A1 Birtley to Coal House

2.5 Engineering Section Drawings

ENGINEERING SECTION DRAWINGS

Version	Date	Status of Version		
Rev 2	20/04/2020	Examination Deadline 4 (Viaduct Options)

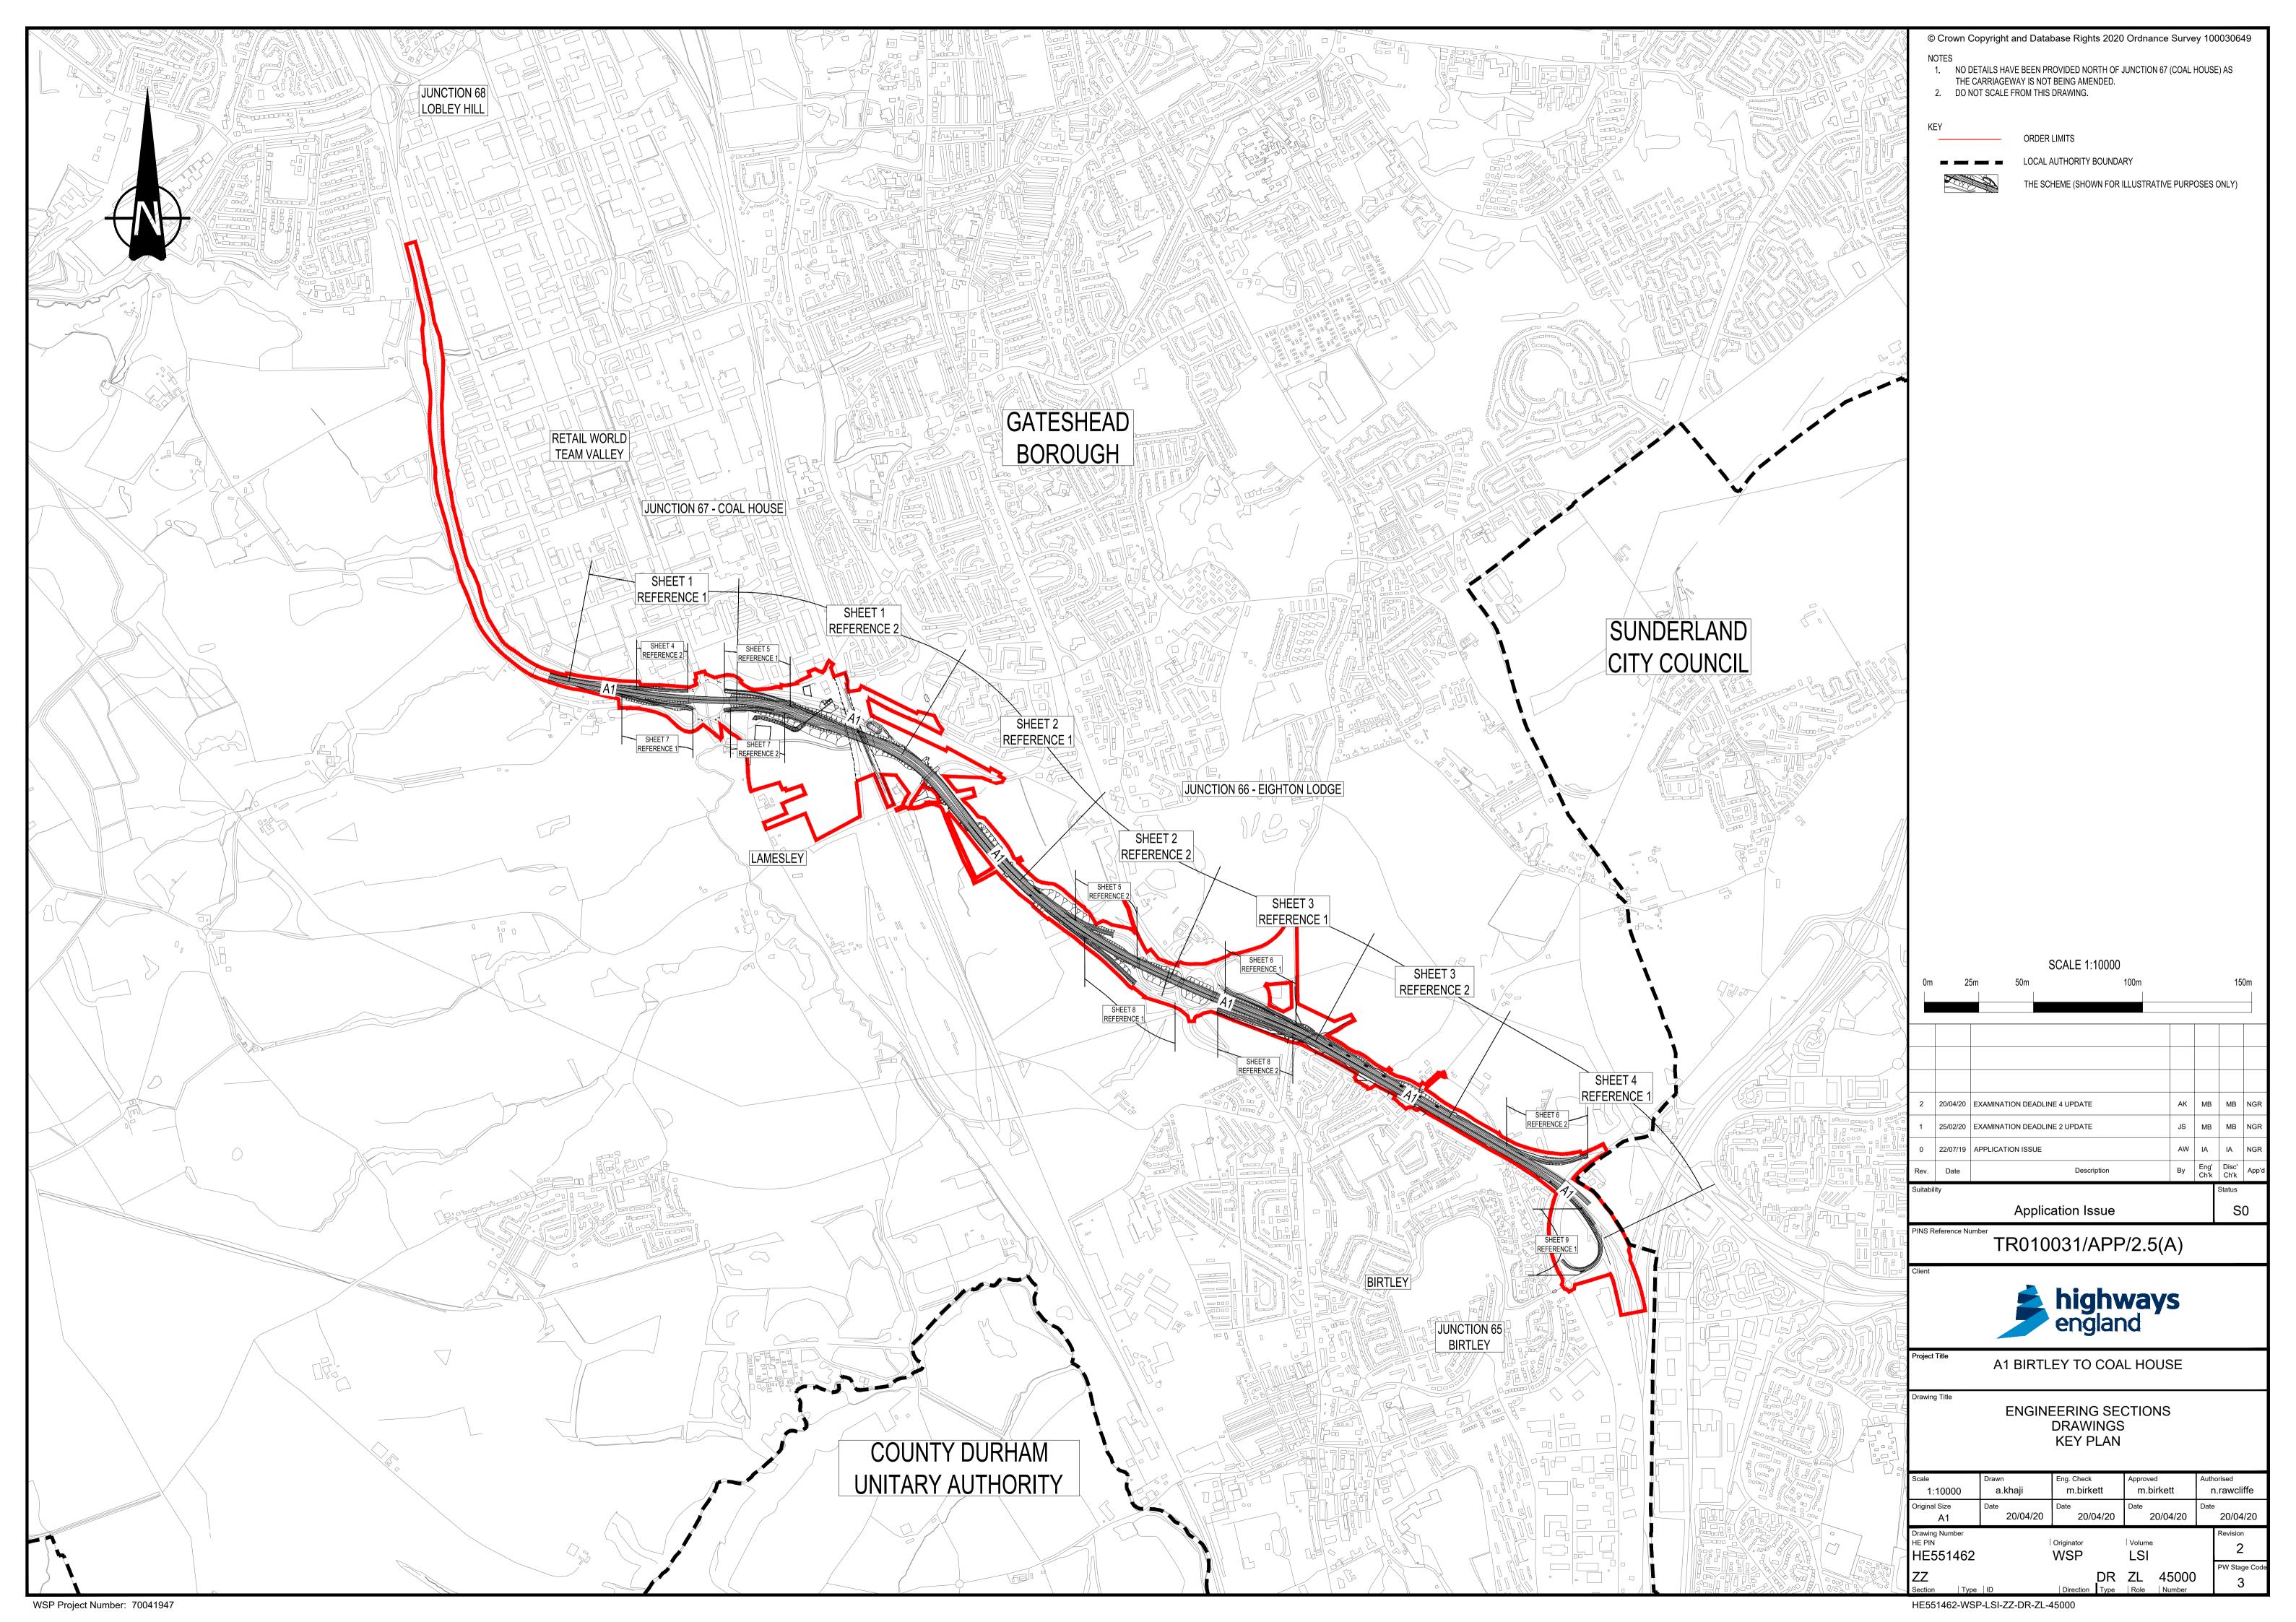
- The key plan has been updated to include an additional area of land within the Order Limits and the option of narrower lanes over the Kingsway Viaduct.

REGULATION 5(2)(o) AND REGULATION 6(2) SHEET 1 OF 9

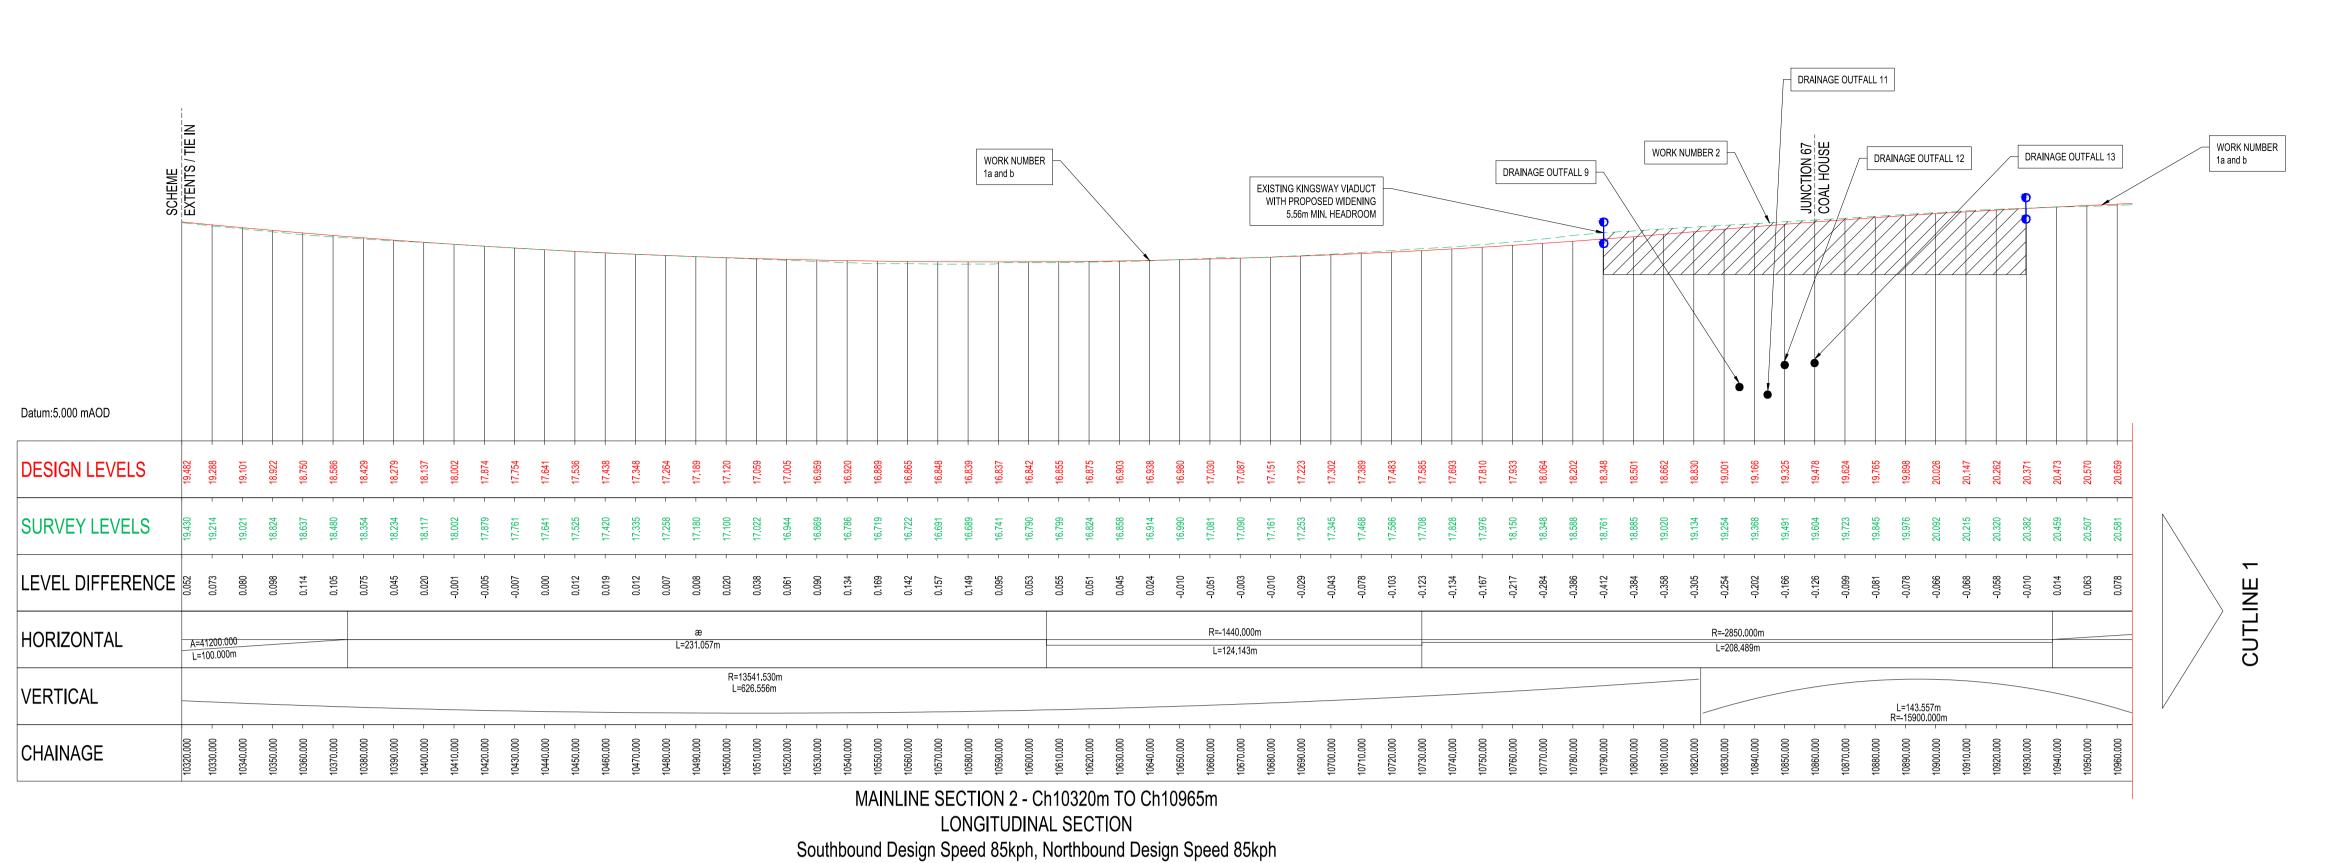
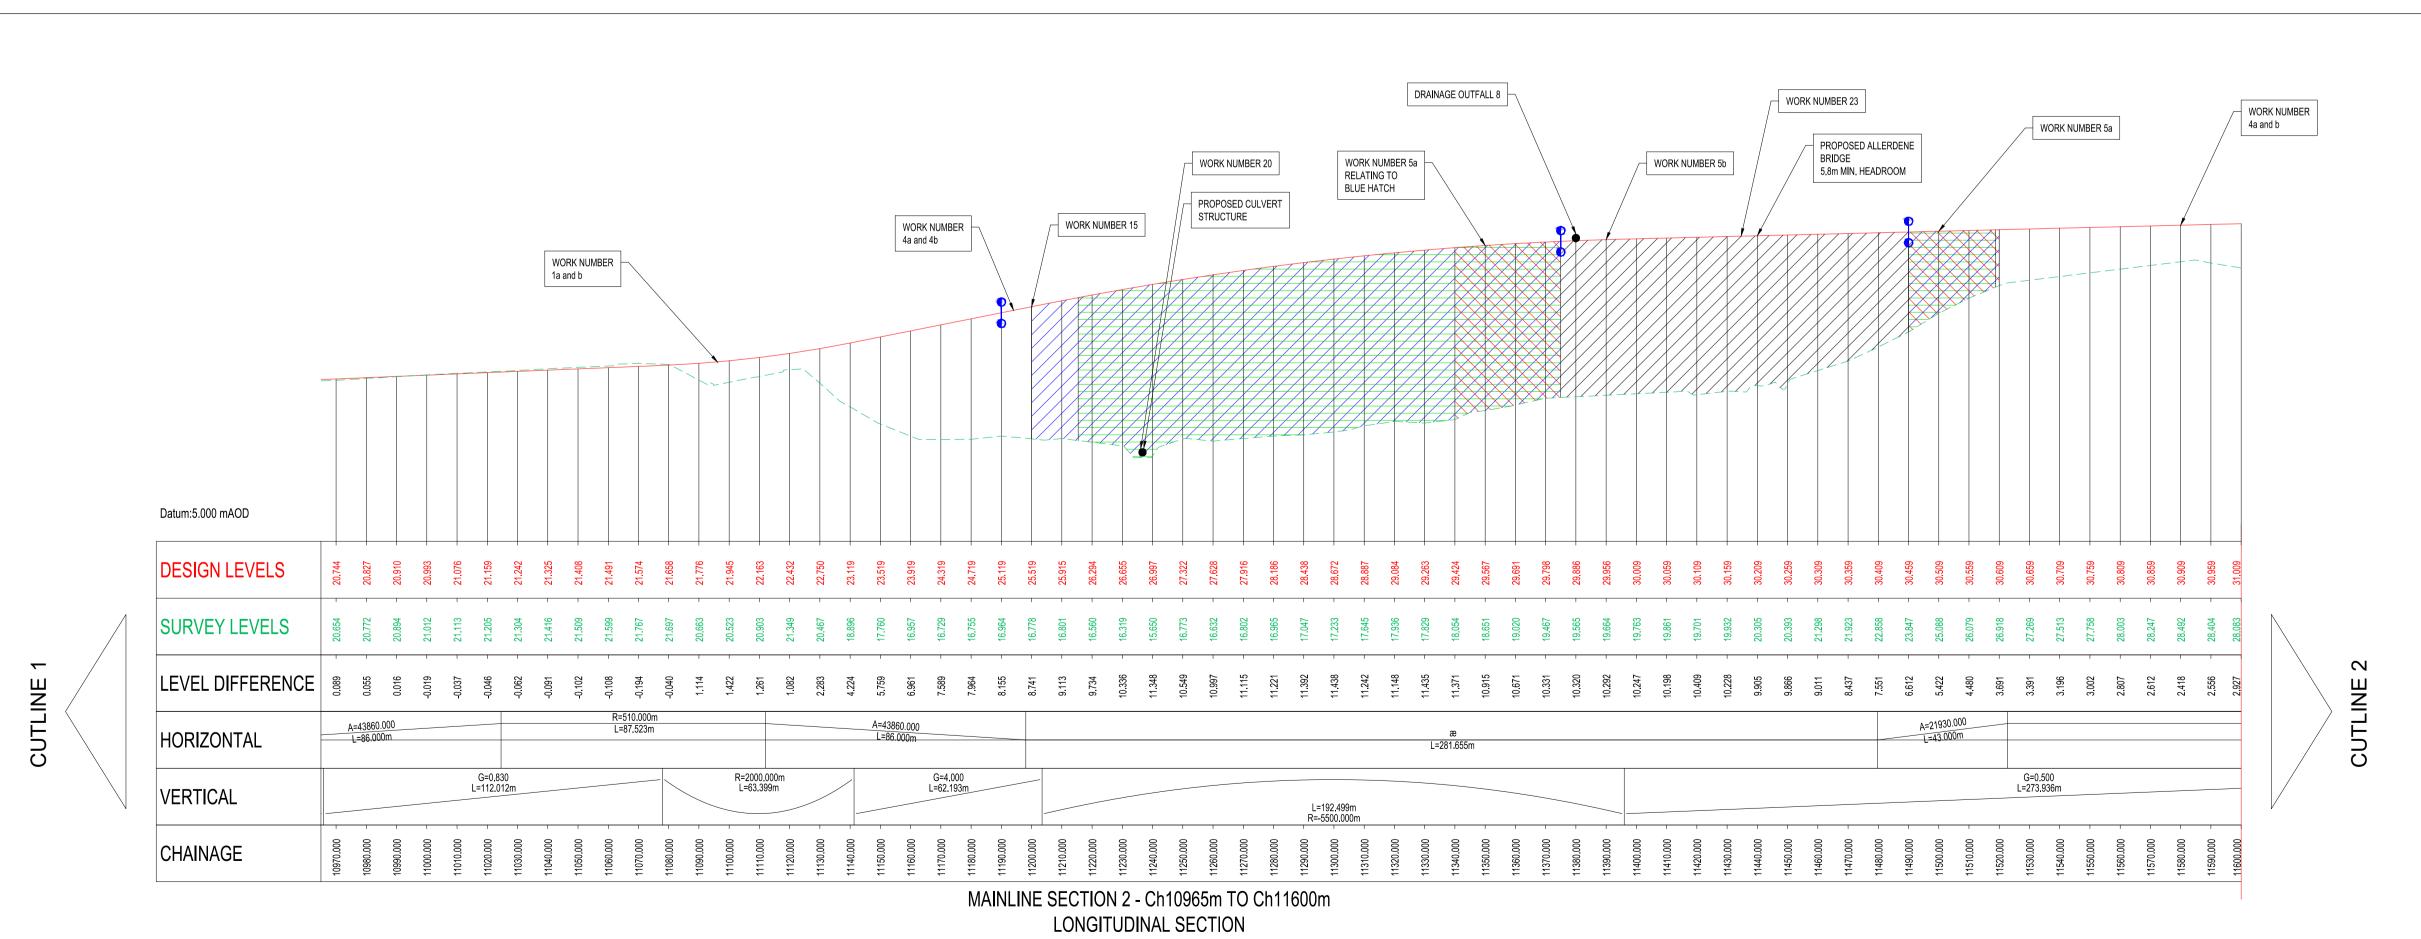
- Sheet 1 has been updated to show the 3-span bridge option.
